CALIFORNIA ENERGY COMMISSION

WELL INTERFERENCE MITIGATION - Figure 1
Three Mountain Power Project - Staff Proposed

ALTERNATIVE SOIL & WATER CONDITIONS

These would replace staff 9-14 or applicant's 9-13

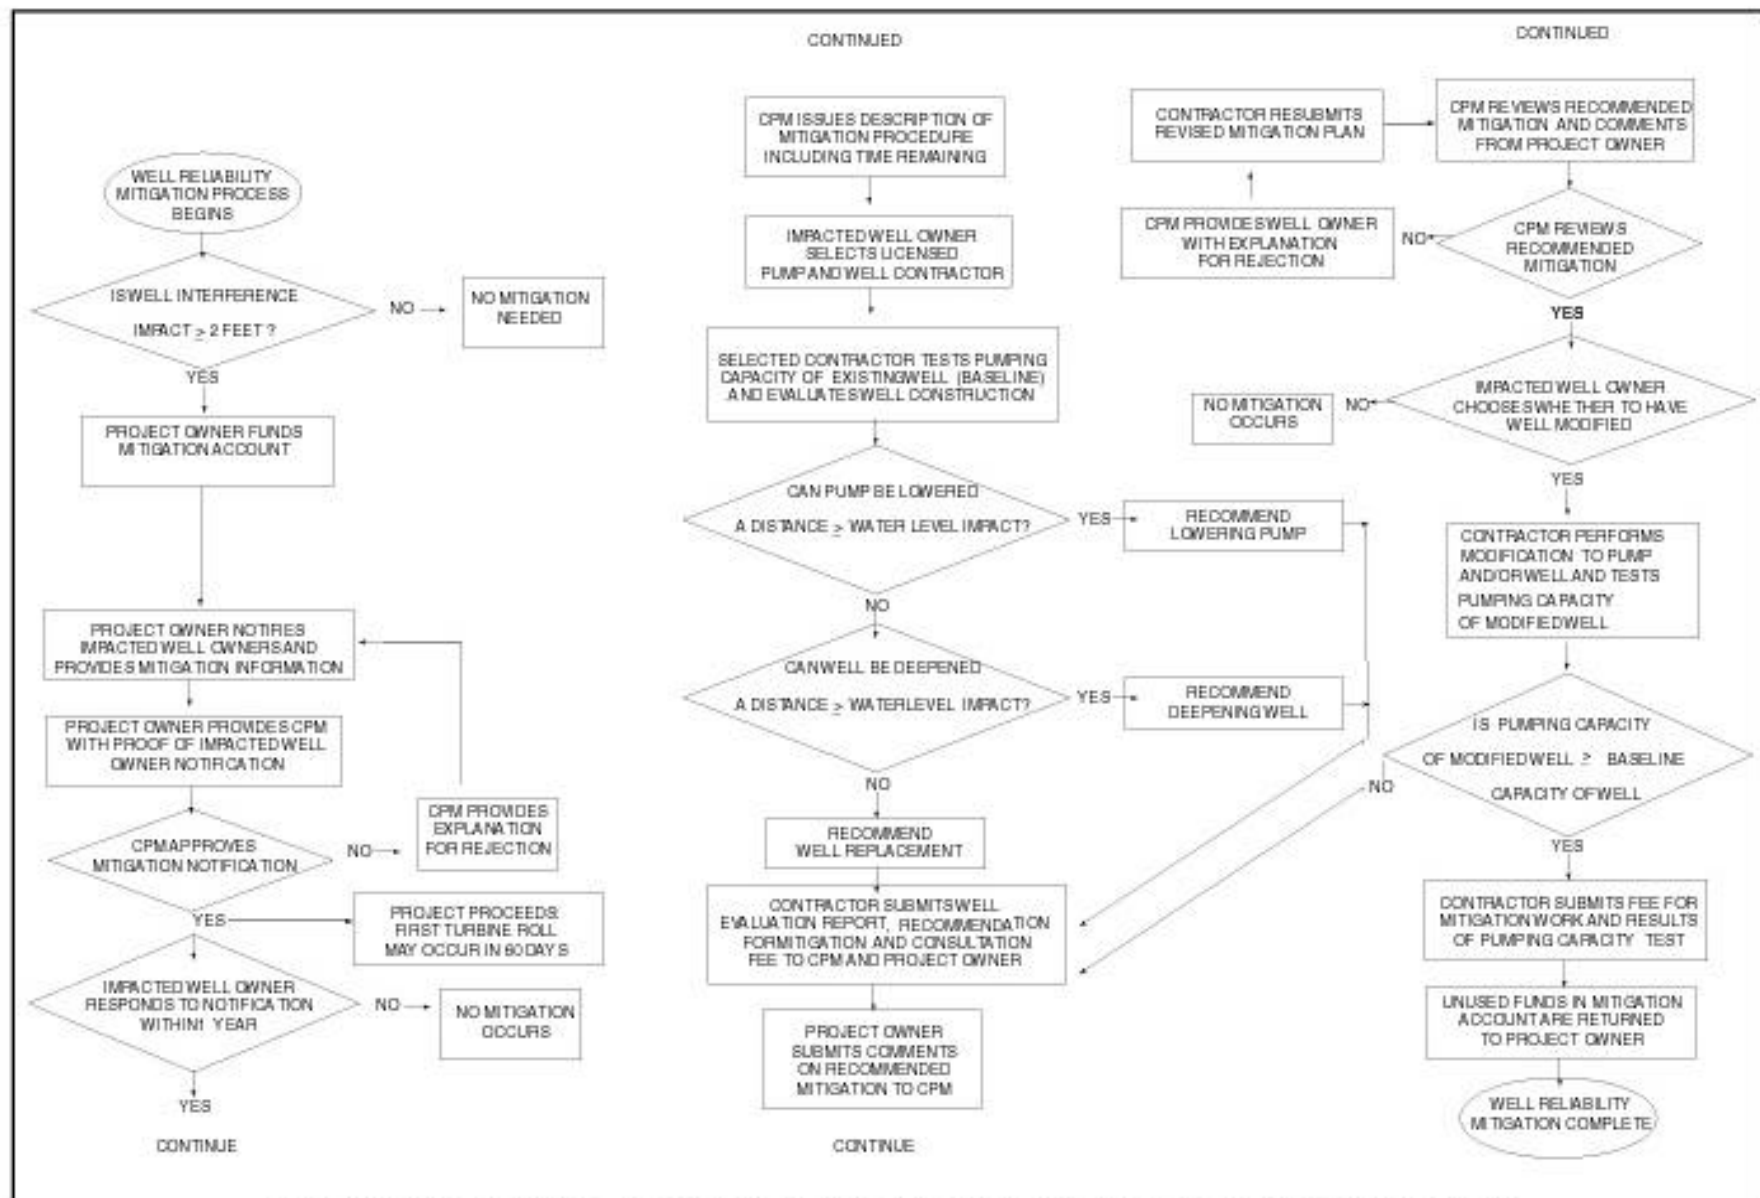
Attached is a decision-tree that we believe will help the parties understand staff proposal. Also attached are draft conditions to implement this alternative approach. We understand the applicant's desire not to delay the decision date of the project. We are providing the attached to expedite the process of developing an adequate record and appropriate conditions. We hope that all parties will be open to discussing this proposal and reaching a stipulation on the appropriate conditions of certification on this project at the scheduled workshop on February 5, 2001. We believe this will serve the objective of obtaining a decision on this project and will ensure that the interests of all parties are protected.
